**ADDITIONAL INFORMATION Reg. Ref. SD21A/0179**

**Re: Removal of selected hedging, the removal of the existing 52 car parking spaces and the construction of a 4-storey apartment building with setbacks at third floor level, total 14 apartments comprising of 1 one-bedroom, 11 two bedroom; 2 three bedroom apartments, all with associated private open spaces areas in the form of balconies; access to the development from existing vehicular and pedestrian entrance from Leixlip Road (R835) and from proposed new vehicular and pedestrian access from Ardeevin Drive; all with associated landscaped courtyard at ground floor level, sedum roof (main roof), bicycle storage, bin storage, signage, associated drainage and site development works (Protected Structure RPS No. 094).**

Reference Image 4: highlighting Heights of Proposed Map in the context of the Subject site

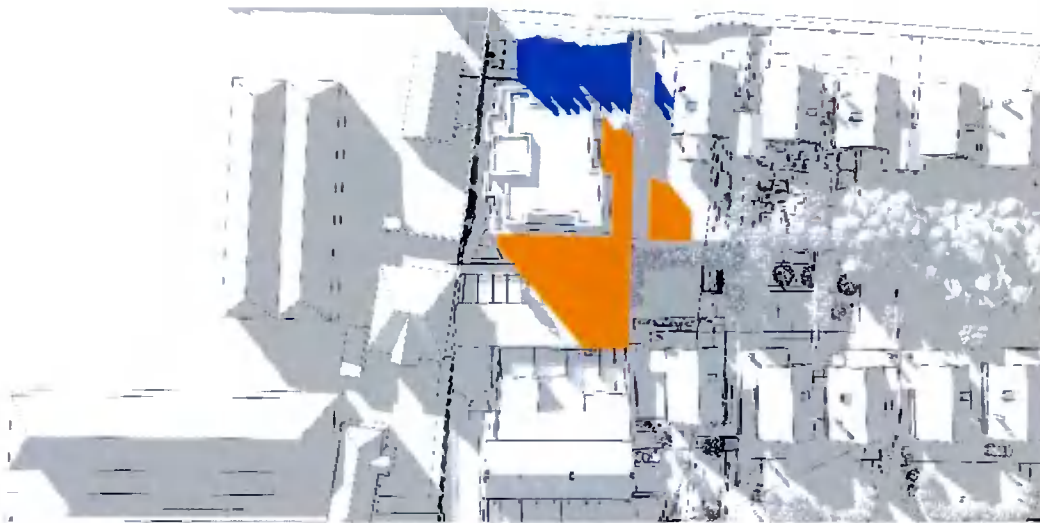
**- MARCH:**

Note the improvement highlighted in **blue** between the existing site and the current proposal due to the removal of existing shrubbery and trees (this also improves the shadow casted by the trees to No. 21 Ardeevin Drive). Furthermore, the highlighted area in **orange** shows the shadow casted by the proposed development which indicates that shadowing occurs Predominantly within the development with only minor

shadow casting toward the back garden of No. 21 Ardeevin Drive (please see below reference image 4 of Heights Map in the context of the Subject site)

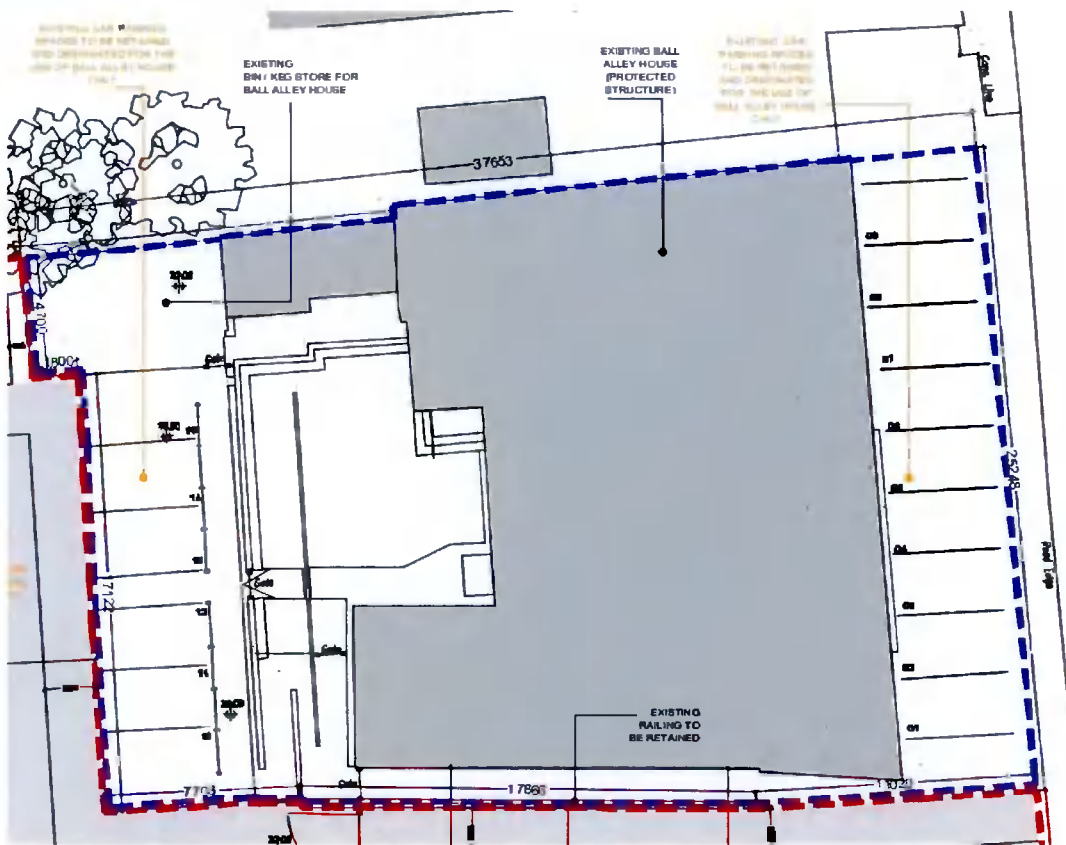
- b) A swept path analysis drawing (i.e. Autotrack or similar) demonstrating that fire tenders and large refuse vehicles can access/egress the site.

**Response:**

Please refer to drawings enclosed as prepared by Molony Millar Consulting demonstrating vehicle swept path analysis.

Reference Image 10: proposed plans highlighting bicycle parking within the development

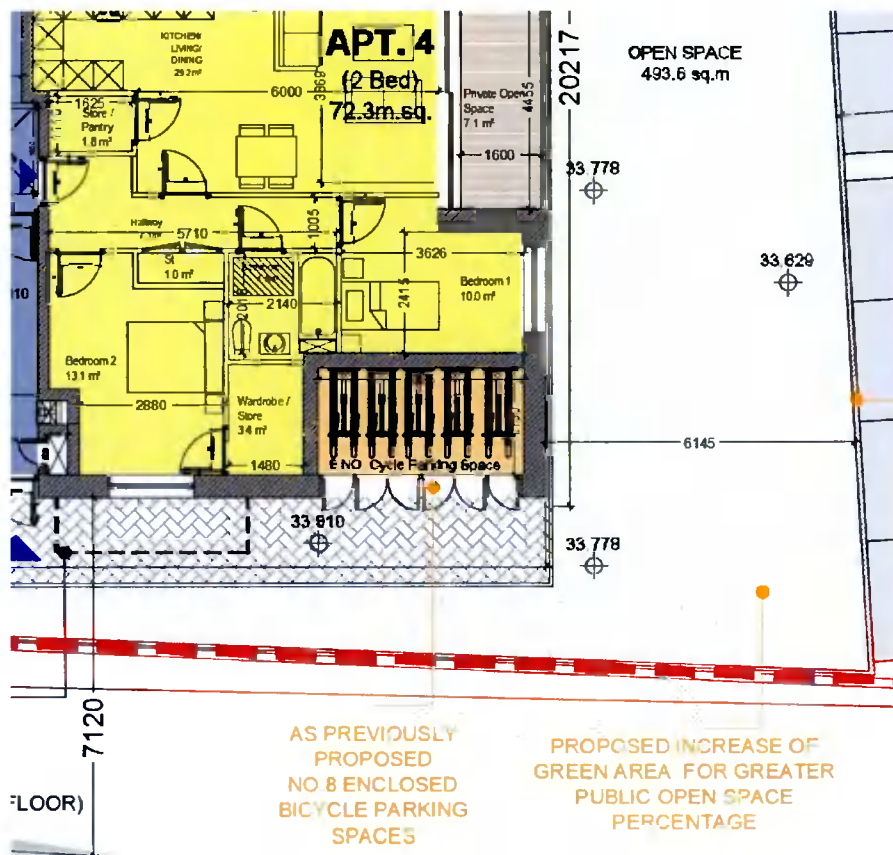
- d) A revised layout showing the car parking, bicycle parking and pedestrian routes within the development. Please refer to Table 11.22: Minimum Bicycle Parking Rates- SDCC County Development Plan 2016-2022.
- i. The minimum width of footpaths shall be 1.8m wide to aid mobility impaired users.
  - ii. All external bicycle parking spaces shall be covered.
  - iii. Footpath layout shall provide adequate connectivity around the development and footpaths on the main road particularly Ardeevin Drive.

In terms of bicycle storage, Table 11.22: Minimum Bicycle Parking Rates- SDCC County Development Plan 2016-2022. States that 1 bike space per 5 apartments long term and 1 per 10 apartments short term is required. As per the initial application submitted to the council, 8 no bicycle parking spaces is proposed in an enclosed area within the proposed building (see attached reference image 6), given that the proposal is for No. 14 apartments the minimum requirement according to the table from SDCC County Development Plan is circa 5 bike spaces for the overall development thus the proposed 8 No. bike store is deemed to be sufficient.
